Mr Mee Access table prepared by Peter Cole of Ceres Property

Accesses - Retained Land Affected by Lower Thames Crossing

PLAN 5

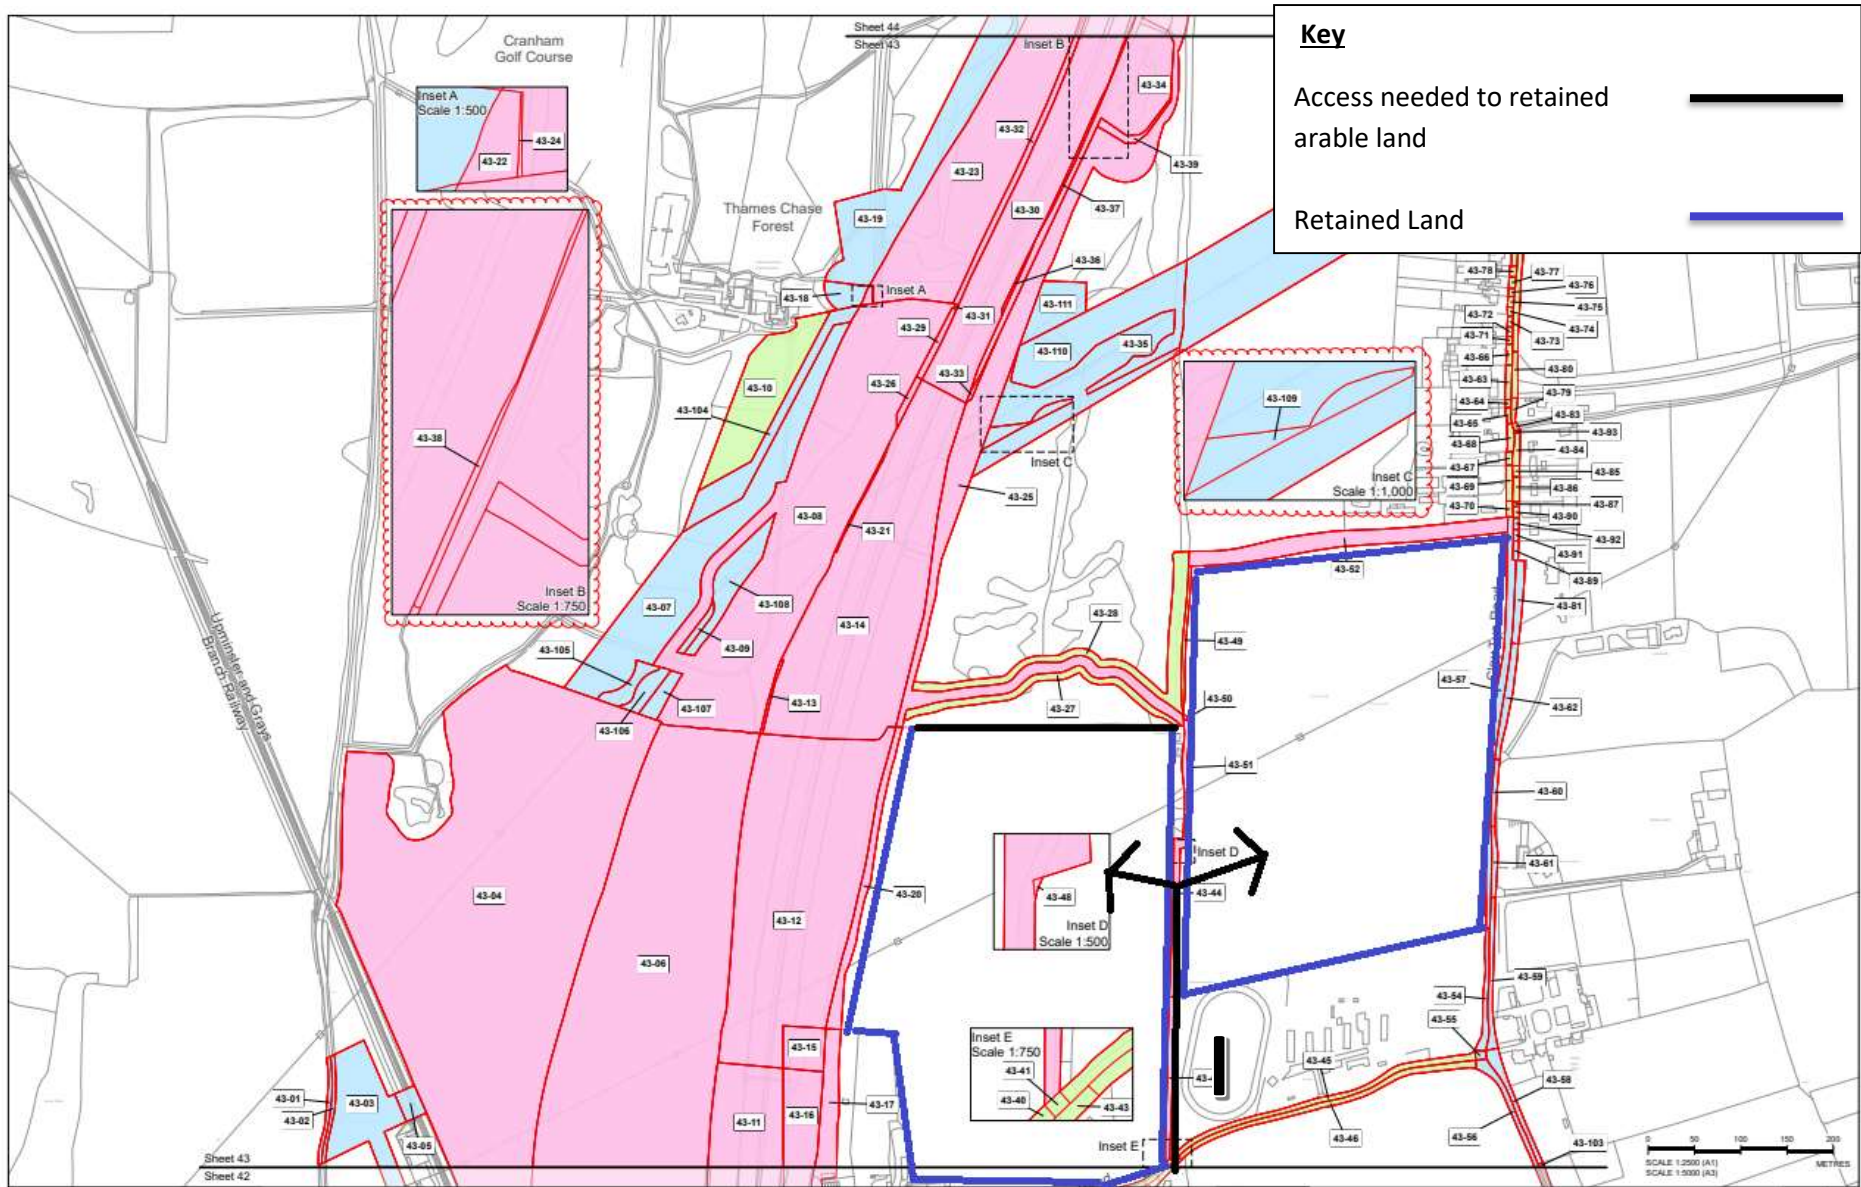
Applicant's Plan which has been annotated by Peter Cole	Plan 4	Plan 4	Plan 5
Current Access	Access to the field outlined in purple is currently taken from Ockendon Road, over the arable field known as Hobbs Hole Field and over Pike Lane.	Access to the pond known as Hobb Hole Pond is currently from Pike Lane.	Access to the field outlined in purple is currently from Ockendon Road. The track is owned by National Highways as part of the M25 construction and our client has an all-purpose right of way over the track to farm the land.
Applicant's proposed replacement access to allow continued use of retained arable land	Point G on the above plan	Point H on the above plan	Point I on the above plan
Description of Applicant's proposed replacement access	Access is barred	Access is barred	There is an existing access where the Applicant proposes to provide its replacement access which is Approx 7 metres in width

Effects of LTC Scheme, and comments on the suitability of	Lower Thames Crossing will sever this current access. There is no designed access to this retained land and access to the land would be severed.	Lower Thames Crossing will sever this current access. There is no designed access to this retained	The land is proposed to be permanently acquired to accommodate a WCH route.

<p>replacement access</p>	<p>Access up Pike Lane is not suitable for agricultural equipment with the width restrictions and crossing over the Railway bridge. Access down Pike Lane is not suitable for agricultural equipment with the width restrictions and the distance from the farmstead.</p>	<p>pond and access to the pond would be severed.</p>	
<p>Photo from Roadside</p>			
<p>Orientation of Photo</p>	<p>Looking north west along Pike lane with "Point G" to the left hand side.</p>	<p>Looking east at Pike lane to access Hobbs Hole Pond.</p>	<p>Looking east on Ockendon road with "Point I" on the right hand side.</p>
<p>Result of lost access</p>	<p>There is no access provided by the Applicant. Without one Mr Mee cannot farm the land.</p>	<p>There is no access provided by the Applicant. Without one Mr Mee cannot let the pond out for fishing or use it.</p>	<p>The track is scheduled to be permanently acquired removing Mr Mee's access rights over this track. Without access rights, Mr Mee will not be able to farm the land.</p>

<p>Mr Mee's need for new access</p>	<p>Access to this land at "Point F" is required of at least 5 metres in width and suitable for a turning circle to cater for farm vehicles and machinery (e.g. combine and tractor and trailers). This may need to be wider to comply with highway safety requirements i.e the need for visibility splays to ensure that it is safe.</p> <p>We require an access from "Point G" of at least 5 metres in width to come off the arable field known as Hobbs Hole onto Pike Lane. This may need to be wider to comply with highway safety requirements i.e the need for visibility splays to ensure that it is safe.</p>	<p>Access to this pond at "Point H" will need to be at least 4 metres in width and suitable for a turning circle to cater for domestic vehicles. This may need to be wider to comply with highway safety requirements i.e the need for visibility splays to ensure that it is safe.</p> <p>Access to the land will need to provide suitable security measures i.e. a reinforced gate with poacher blocks to prevent unauthorised access.</p> <p>It is the case in this part of south Essex, near to a large urban conurbation and easy main routes of road access that the pressure from unauthorised users is evidently of such a degree that when barriers have been used, they have been damaged.</p>	<p>The existing access and track is sufficient for agricultural equipment and needs to remain.</p> <p>It is unclear how the WCH will interact with the agricultural access as we don't know the design requirements of the WCH.</p> <p>The applicant will need to provide an all-purpose right of way on the track to ensure the track can continue to be used by Mr Mee to access his arable fields.</p> <p>Access to the land will need to provide suitable security measures i.e., a reinforced gate with poacher blocks to prevent unauthorised access.</p> <p>It is the case in this part of south Essex, near to a large urban conurbation and easy main routes of road access that the pressure from unauthorised users is evidently of such a degree that when barriers have been used, they have been damaged.</p> <p>The Applicant will need to ensure the safe passage of any WCH users onto Ockendon Road which is a busy road with blind corners.</p>

<p>Overall conclusions on Applicant Proposal for access</p>	<p>The Applicant has not provided an access to this land. The Applicant will need to provide:</p> <ol style="list-style-type: none"> 1. An access to this land in line with the specifications requested above. 2. Detailed design on the specification requested above 	<p>The Applicant has not provided an access to this pond. The Applicant will need to provide:</p> <ol style="list-style-type: none"> 1. An access to the pond in line with the specifications requested above. 2. Detailed design on the specification requested above 	<p>The Applicant has not provided access rights to this land. The Applicant will need to provide:</p> <ol style="list-style-type: none"> 1. An access to the land in line with the existing specifications 2. Detailed design on the specification requested above 3. There is no detailed design on the how the WCH will interact with the access and how unauthorised access can be prevented.

PLAN 6

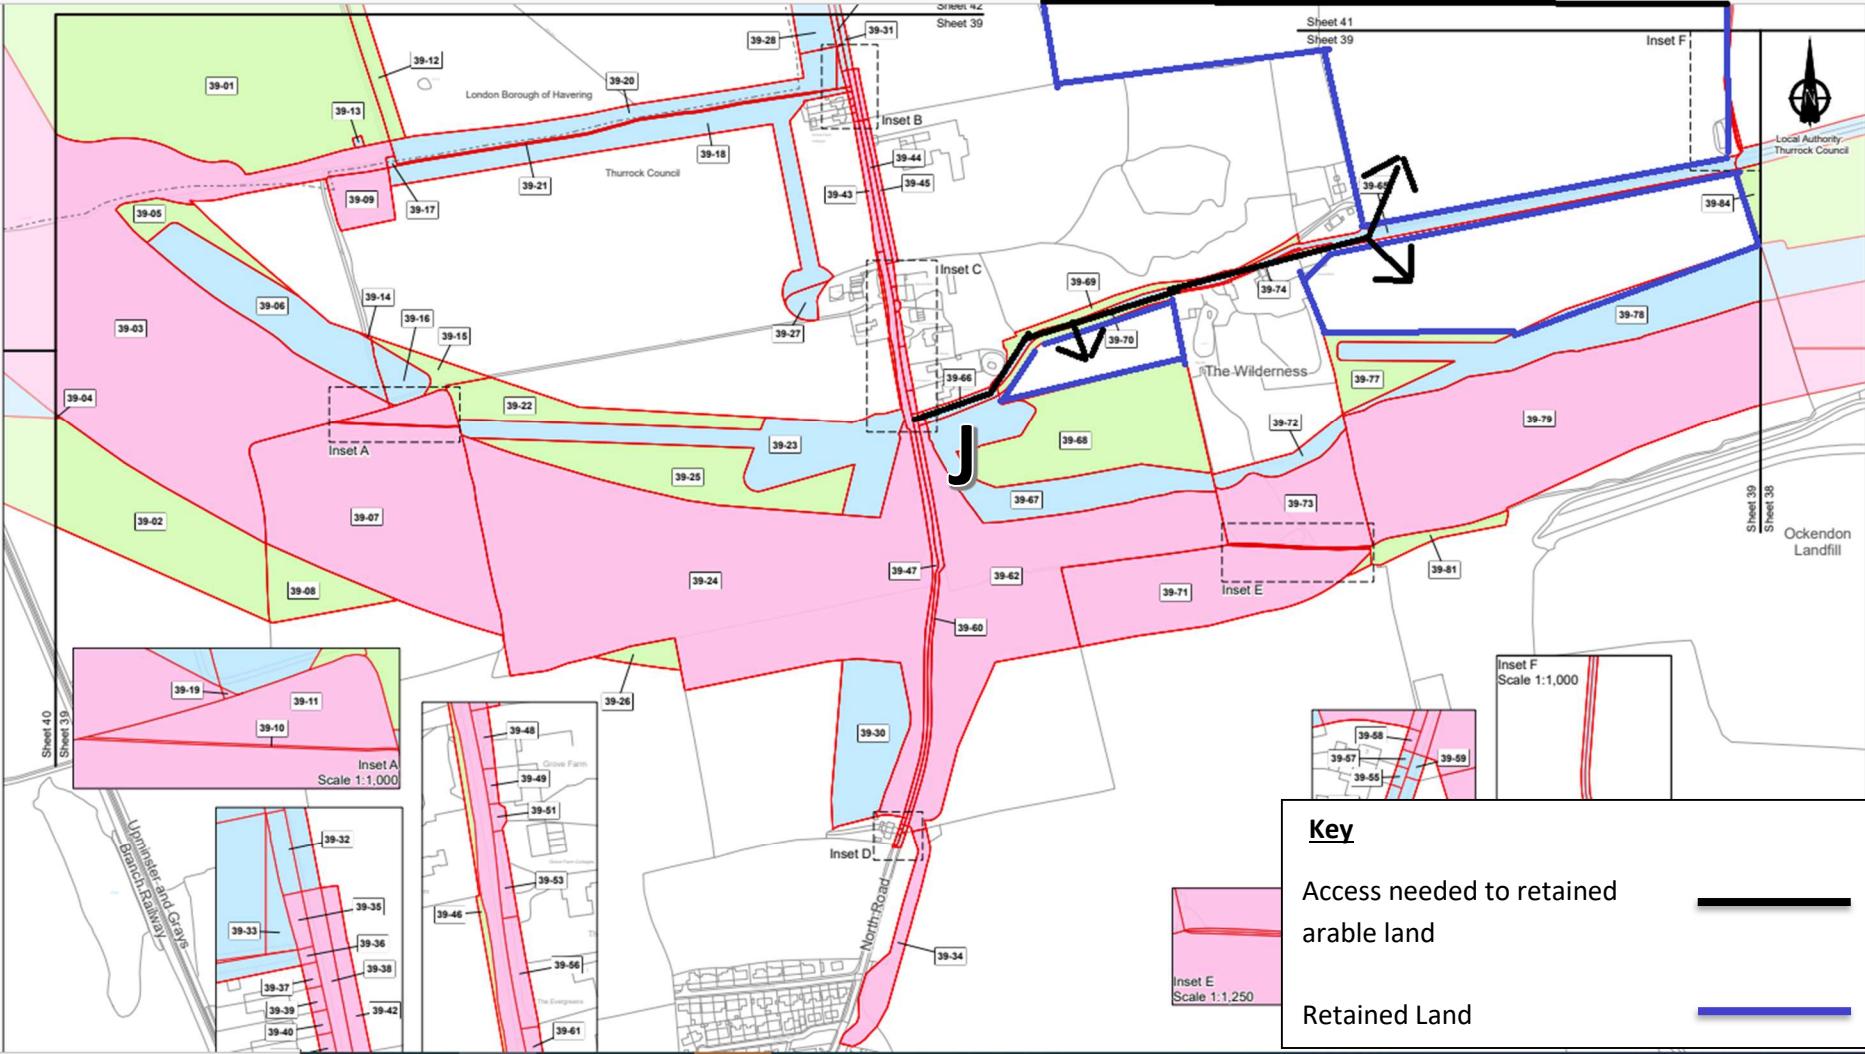
Applicant's Plan which has been annotated by Peter Cole	Plan 6	Plan 7	Plan 8
Current Access	Access to the fields outlined in purple is currently from North Road.	Access to the fields outlined in purple is currently from Dennises Lane. The access is approx. 7 metres in width.	Access to the fields outlined in purple is currently from Dennis Road. The access is approx. 6 metres in width.
Applicant's proposed replacement access to allow continued use of retained arable land	Point J on the above plan	Point K on the above plan	Point L on the above plan
Description of Applicant's proposed replacement access	There is an existing access where the Applicant proposes to provide its replacement access which is Approx 10 metres in width	Access is barred	Access is barred
Effects of LTC Scheme, and comments on the suitability of replacement access	<p>The Applicant will use the access and track for construction and a new WCH and will be shared with the current use of accessing the arable land.</p> <p>The track is a single track road and is not suitable for additional users.</p>	The Applicant is proposing a new WCH which will block this access.	The Applicant is proposing a new WCH which will block this access.

<p>Photo from Roadside</p>			
<p>Orientation of Photo</p>	<p>Looking south on North Road with "Point J" on the left hand side.</p>	<p>Looking east along Dennises Lane with "Point K" on the right hand side</p>	<p>Looking north on Dennis Road with "Point L" on the right hand side</p>
<p>Result of lost access</p>	<p>The Applicant is trying to utilise an existing access and provide multiple users down a single-track road. This will result unpassable traffic.</p>	<p>There is no access provided by the Applicant. Without one Mr Mee cannot farm the land.</p>	<p>There is no access provided by the Applicant. Without one Mr Mee cannot farm the land.</p>
<p>Mr Mee's need for new access</p>	<p>The existing access is sufficient for agricultural equipment and needs to remain.</p> <p>It is unclear how the WCH and construction traffic will interact with the agricultural access as we don't know the design requirements of the WCH. The access and track will need to be improved to cater for both uses.</p> <p>The Applicant will need to construct passing bays if this access will be shared with construction traffic.</p> <p>Access to the land will need to provide suitable</p>	<p>The existing access is sufficient for agricultural equipment and needs to remain.</p> <p>Suitable security measures i.e. a reinforced gate with poacher blocks to prevent unauthorised access will need to be installed. It is the case in this part of south Essex, near to a large urban conurbation and easy main routes of road access that the pressure from unauthorised users is evidently of such a degree that when barriers have been used, they have been damaged.</p>	<p>The existing access is sufficient for agricultural equipment and needs to remain.</p> <p>Suitable security measures i.e. a reinforced gate with poacher blocks to prevent unauthorised access will need to be installed. It is the case in this part of south Essex, near to a large urban conurbation and easy main routes of road access that the pressure from unauthorised users is evidently of such a degree that when barriers have been used, they have been damaged.</p>

<p>security measures i.e. a reinforced gate with poacher blocks to prevent unauthorised access. It is the case in this part of south Essex, near to a large urban conurbation and easy main routes of road access that the pressure from unauthorised users is evidently of such a degree that when barriers have been used, they have been damaged.</p>		
<p>Overall conclusions on Applicant Proposal for access</p>	<p>The Applicant has not detailed any improvements to the track to accommodate additional users. The Applicant will need to provide:</p> <ol style="list-style-type: none"> 1. An access to the land in line with the specifications which is existing today. 2. Detailed design on the specification requested above 3. There is no detailed design on the how the WCH will interact with the access and how unauthorised access can be prevented. 	<p>The Applicant has not provided an access to this land. The Applicant will need to provide:</p> <ol style="list-style-type: none"> 1. An access to the land in line with the specifications which is existing today. 2. Detailed design on the specification requested above 3. There is no detailed design on how the WCH will interact with the access and how unauthorised access can be prevented. 	<p>The Applicant has not provided an access to this land. The Applicant will need to provide:</p> <ol style="list-style-type: none"> 1. An access to the land in line with the specifications which is existing today. 2. Detailed design on the specification requested above 3. There is no detailed design on the how the WCH will interact with the access and how unauthorised access can be prevented.

PLAN 8

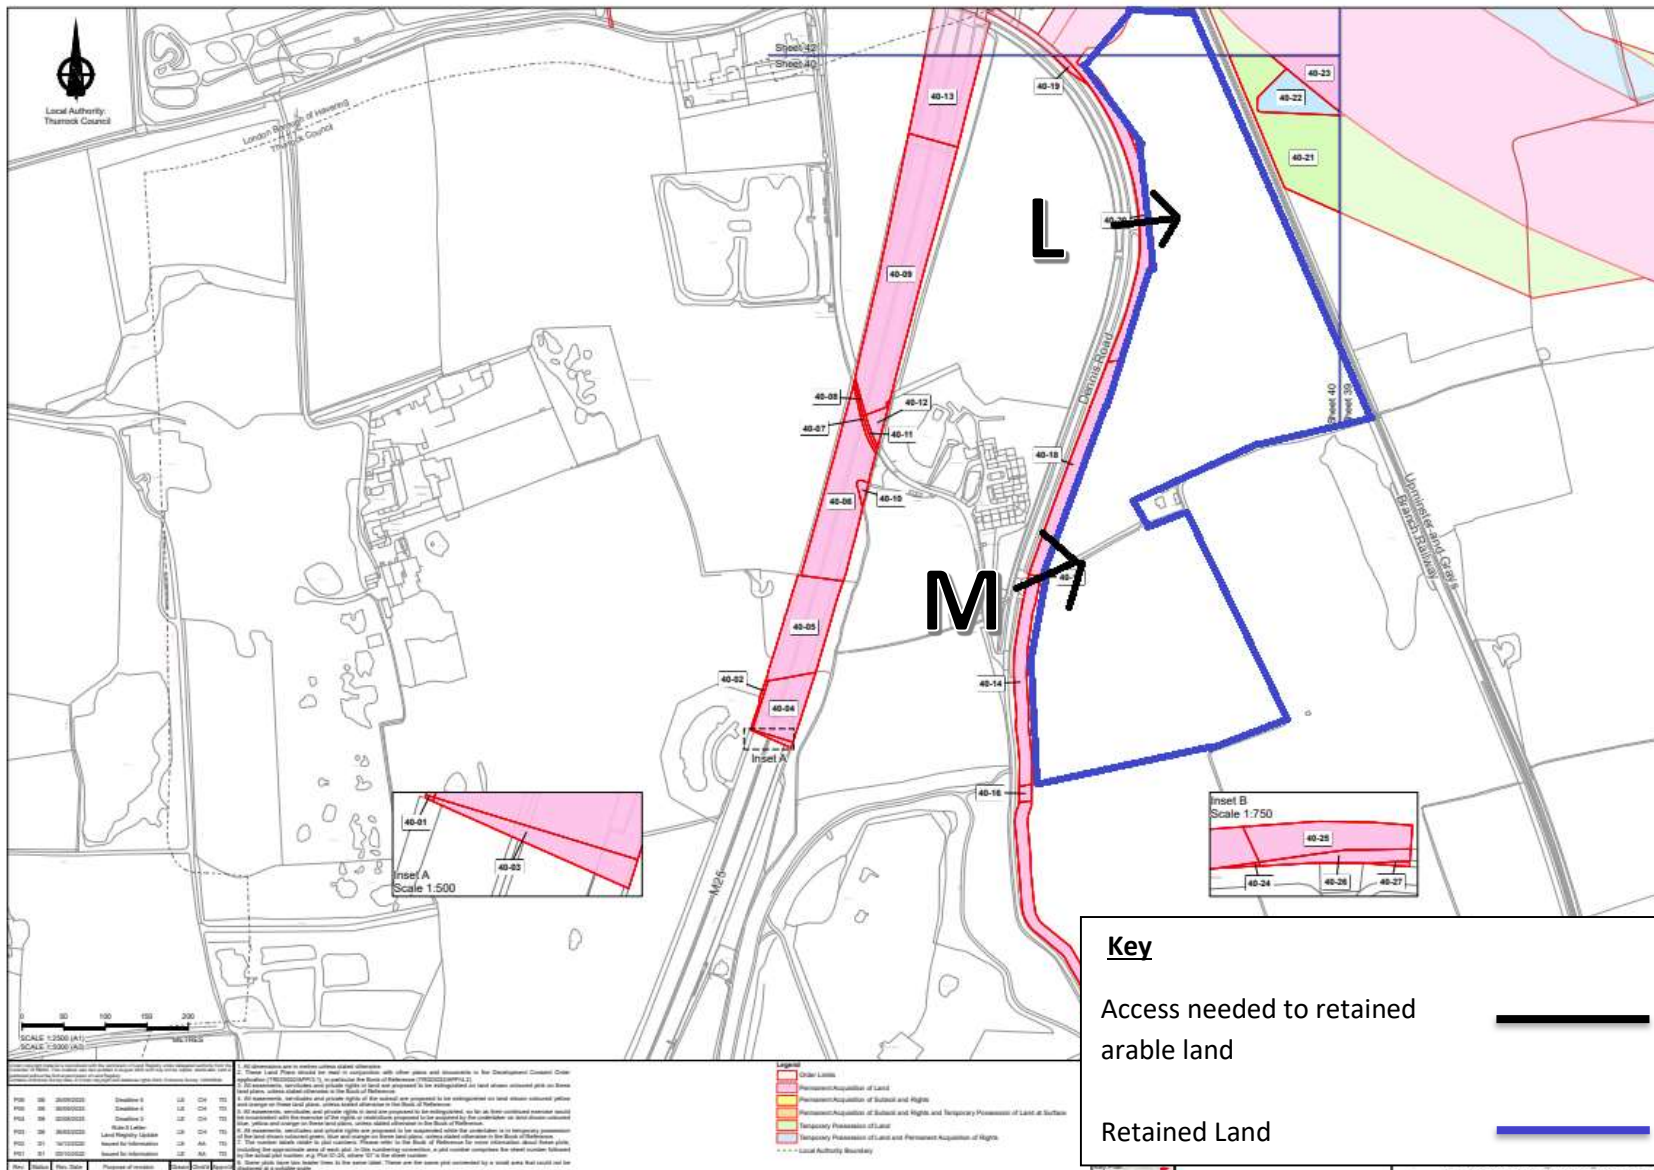
Applicant's Plan which has been annotated by Peter Cole	Plan 8	Plan 9
Current Access	Access to the fields outlined in purple is currently from Dennis Road. The access has a 10 meter width.	Access to the field outlined in purple is currently from the arable field to the south.
Applicant's proposed replacement access to allow continued use of retained arable land	Point M on the above plan but not provided by the Applicant.	Point N on the above plan
Description of Applicant's proposed replacement access	Access is barred.	There is no current access and this will be a new access
Current Access, Effects of LTC Scheme, and comments on the suitability of replacement access	The Applicant is proposing a new WCH which will block this access.	<p>A new WCH overpass on the Lower Thames Crossing will sever the current access to this land.</p> <p>The Applicant has currently designed a new access point to the severed arable land from Dennis Road.</p> <p>The Applicant is proposing a new WCH which will be in front of this new access.</p>

<p>Photo from Roadside</p>		
<p>Orientation of Photo</p>	<p>Looking north on Dennis Road with "Point M" on the right hand side</p>	<p>Looking north on Dennis Road at the proposed new access location - "Point N"</p>
<p>Result of lost access</p>	<p>There is no access provided by the Applicant. Without one Mr Mee cannot farm the land</p>	<p>The Applicant is creating a new access to replace the lost access but without seeing the detail on the design it is unclear if it will be suitable for Mr Mee to access and farm the land.</p>
<p>Mr Mee's need for new access</p>	<p>The existing access is sufficient for agricultural equipment and needs to remain.</p> <p>Suitable security measures i.e. a reinforced gate with poacher blocks to prevent unauthorised access will need to be installed. It is the case in this part of south Essex, near to a large urban conurbation and easy main routes of road access that the pressure from unauthorised users is evidently of such a degree that when barriers have been used, they have been damaged.</p>	<p>Access to this land is required of at least 5 metres in width and suitable for a turning circle to cater for farm vehicles and machinery (e.g. combine and tractor and trailers). This may need to be wider to comply with highway safety requirements i.e the need for visibility splays to ensure that it is safe.</p> <p>Access to the land will need to provide suitable security measures i.e. a reinforced gate with poacher blocks to prevent unauthorised access.</p> <p>It is the case in this part of south Essex, near to a large urban conurbation and easy main routes of road access that the</p>

<p>pressure from unauthorised users is evidently of such a degree that when barriers have been used, they have been damaged.</p> <p>A 5 metre width access track will be required to the severed land from the access.</p>
<p>Overall conclusions on Applicant Proposal for access</p>	<p>The Applicant has not provided an access to this land. The Applicant will need to provide:</p> <ol style="list-style-type: none"> 1. An access to the land in line with the specifications which is existing today. 2. Detailed design on the specification requested above 3. There is no detailed design on the how the WCH will interact with the access and how unauthorised access can be prevented. 	<p>The Applicant has suggested a new access to this land. The Applicant will need to provide:</p> <ol style="list-style-type: none"> 1. Detailed design on the specification requested above 2. There is no detailed design on the how the WCH will interact with the access and how unauthorised access can be prevented.
